2 PROJECT DESCRIPTION

2.1 INTRODUCTION

This section provides a description of the revised RTRP project components proposed by SCE, including facilities and equipment, construction methods and schedule, and operations and maintenance (where different from the 2013 RTRP Final EIR descriptions of construction methods or operations and maintenance). This section does not describe project components that are unchanged from the 2013 RTRP Final EIR (e.g., Wildlife Substation, 230-kV transmission line segment south of Santa Ana River, and interconnect to RPU's 230/69-kV substation).

Figure 2.3-4 Typical Tubular Steel Pole

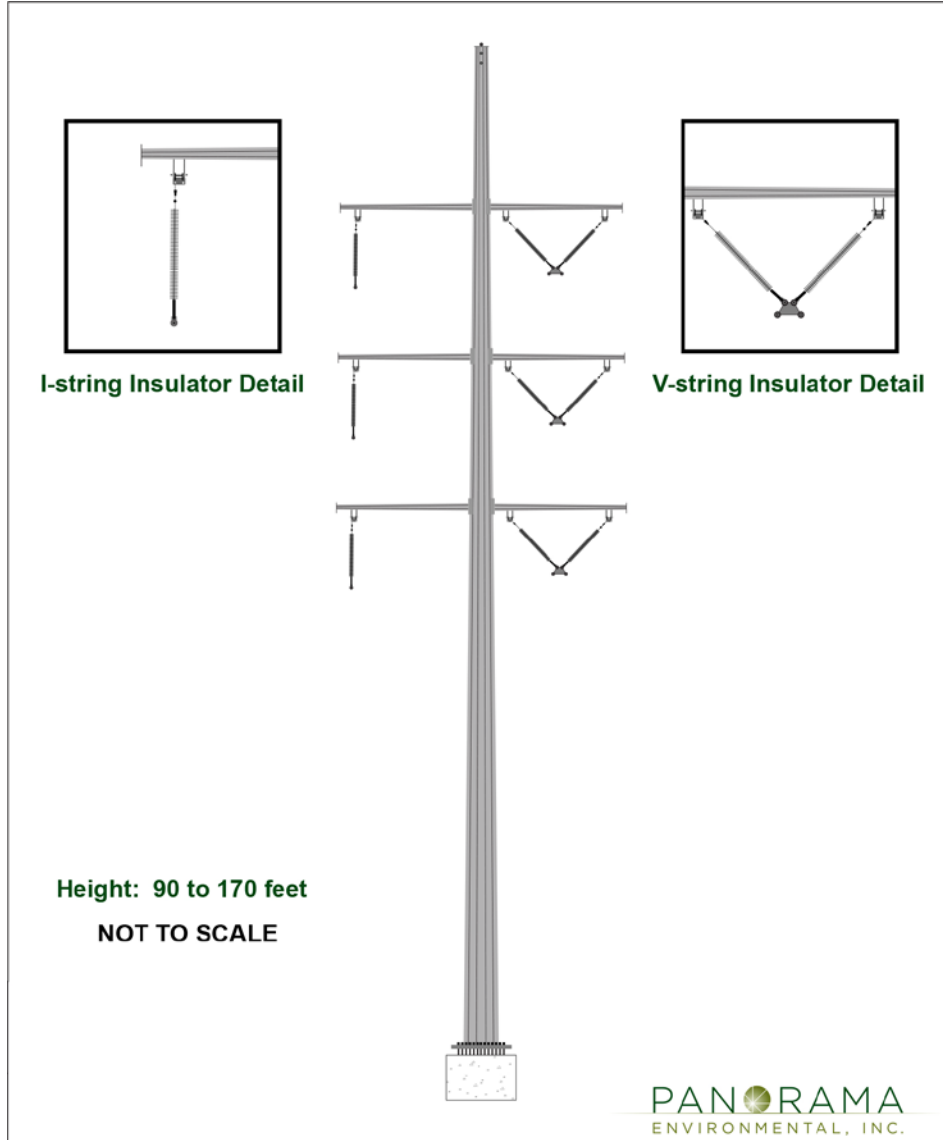
Commented [GB3]: SCE recommends two different figures to reflect a separate I-string and V-string insulator configuration to avoid confusion.

Figure 2.3-5 Typical Riser Pole

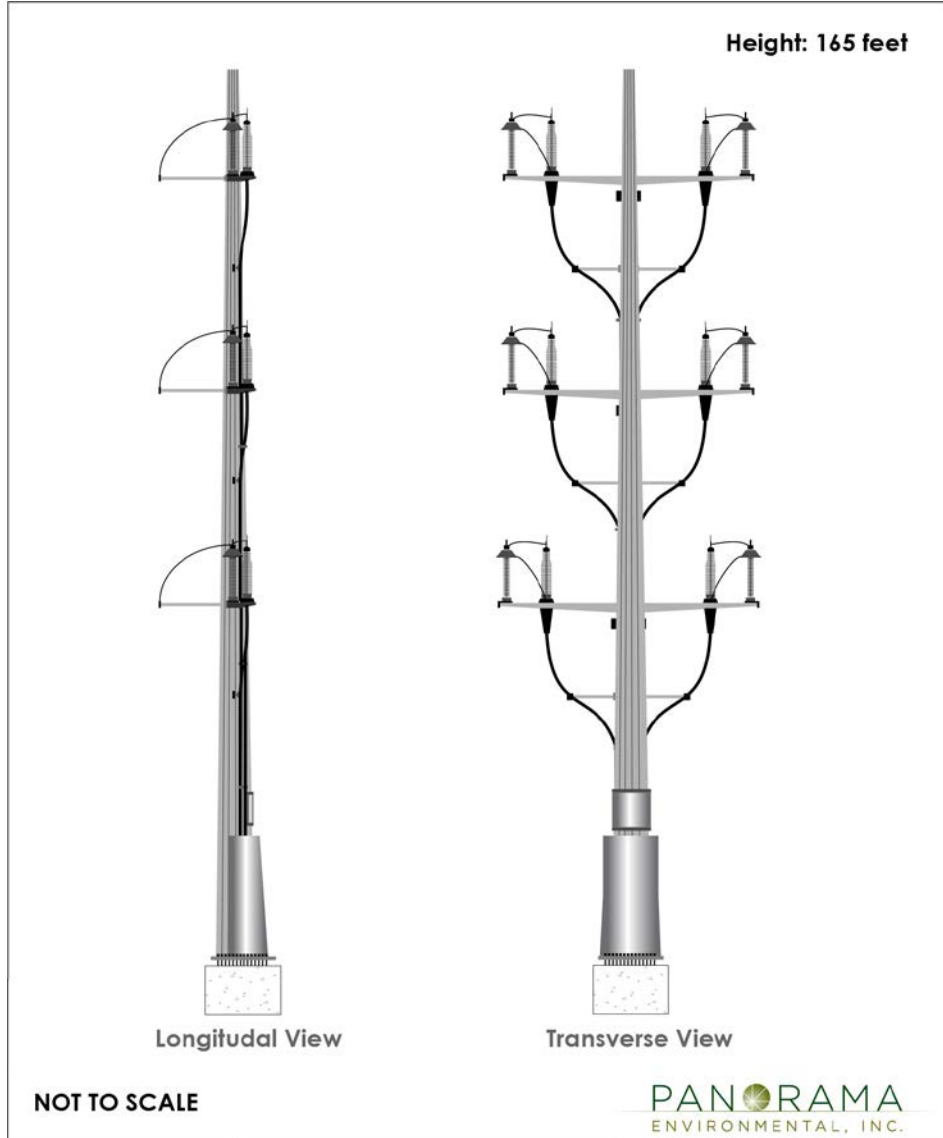
Commented [GB4]:

Commented [MB5R4]: Currently, RTRP is designed for I-string insulators.

Figure 2.3-6 Typical 230-kV Double Circuit Underground Duct Bank

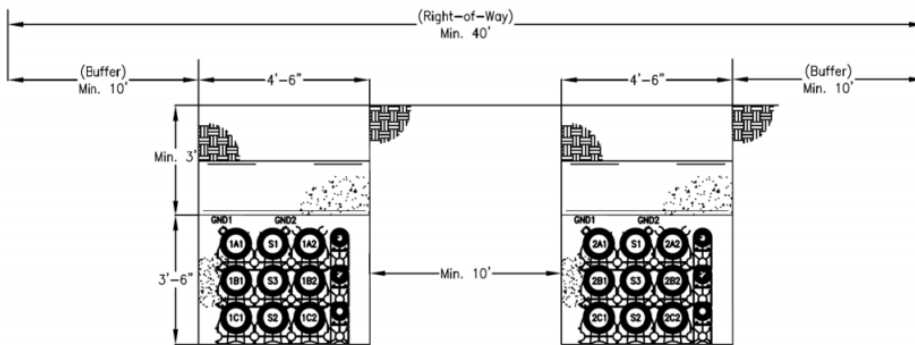
Commented [GB6]:

Commented [RC7R6]: Figure 2.36 is the most recent version of the 230kV vaults.

Figure 2.3-7 Locations 3 and 5 Distribution Line Relocation

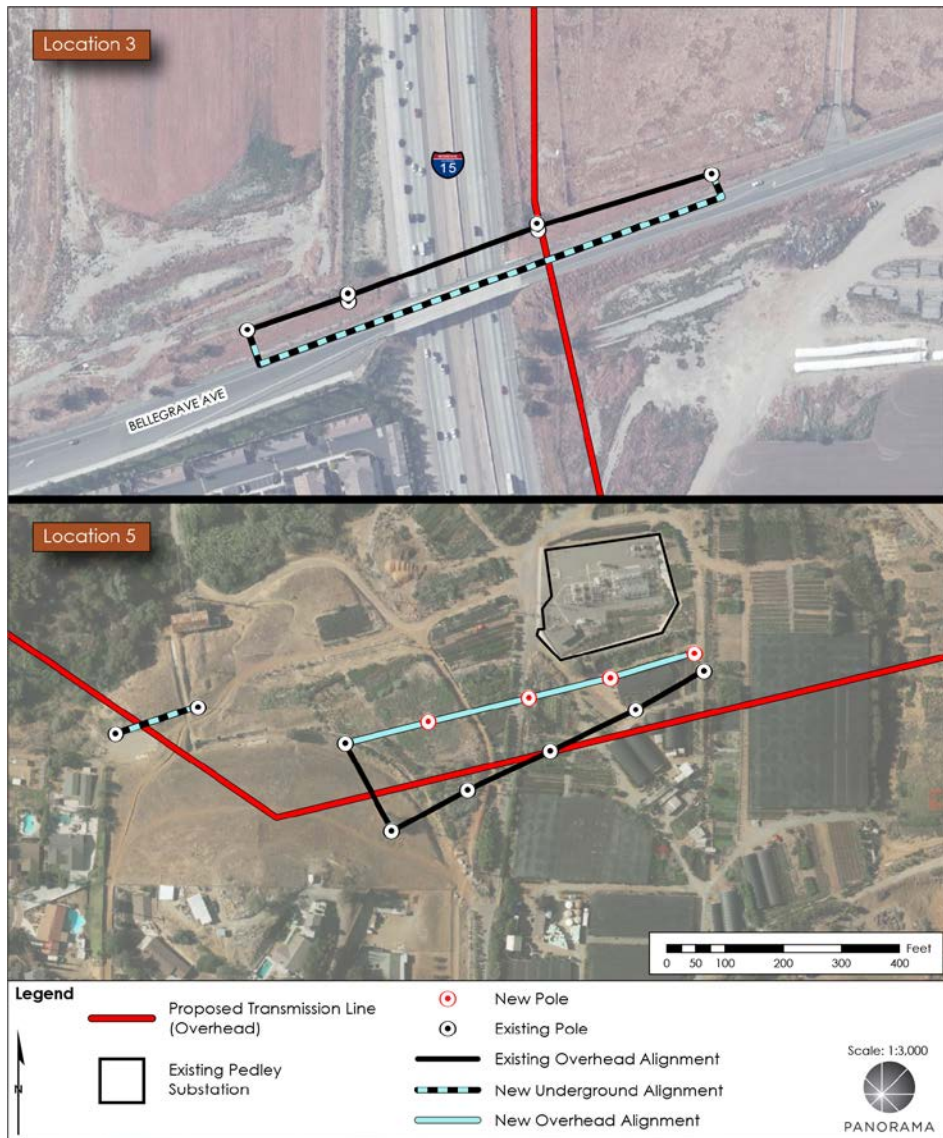
Commented [GB13]: From Paul McCabe: For Location 5 the Underground Alignment is no longer required and will remain as existing overhead with no new activity. And the New Overhead is no longer needed. The Existing Overhead will remain, with no additional changes. Therefore, location 5 is no longer a part of the proposed project.

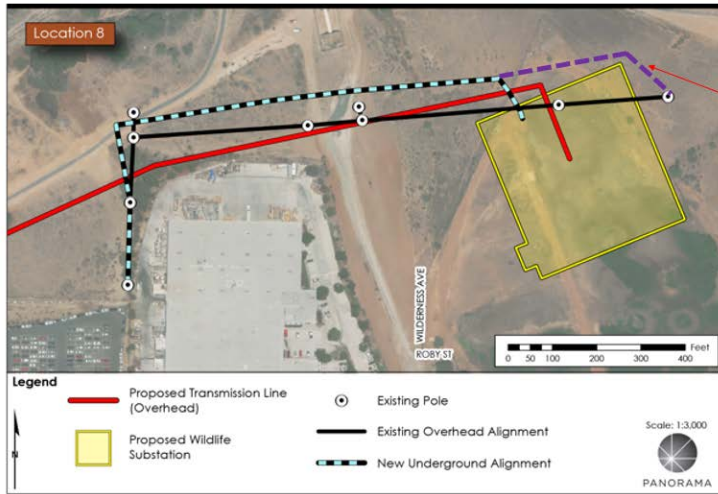
The UG conduit installation needs to be extended to reflect the purple dashed line

Commented [GB14]: SCE is revising the to include the purple line to extend the underground conduit for the distribution line. The blue and black is for the co-location of the telecom and distribution underground conduit. The Telecom will go south into the substation. The distribution continues further east as depicted in purple. The resubmittal of the GIS will also reflect this change.
